BCAC IRC group B 2022-PC

RB3-22

RB45-22

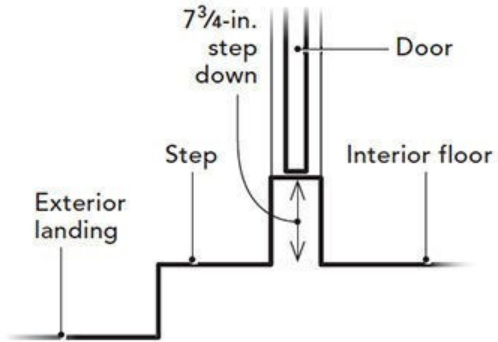
Reason: This proposal started as question – Can the landing or steps into a garage be the same as permitted for exterior doors or not? The following are current requirements - There is a requirement for landings at exterior doors (R311.3) and a requirement for landings at the top and bottom of stairways (R311.7.6). The required egress door has to open directly into a public way, yard or court (R311.1), so it has to be an exterior door. Egress is not permitted through a garage (R311.1).

Interior doors not have requirements for landings, so going out to a single step or multiple steps would be covered by the stairway landing requirement in Section R311.7.6. The current exception clarifies that steps into a garage are considered interior stairways.

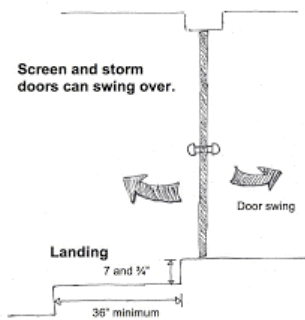
This is what is permitted with current text for exterior doors other than the means of egress doorway. While perhaps there should be a threshold limit (not proposed here), the current allowances is a serious tripping hazard.

Was this not the intended allowance?
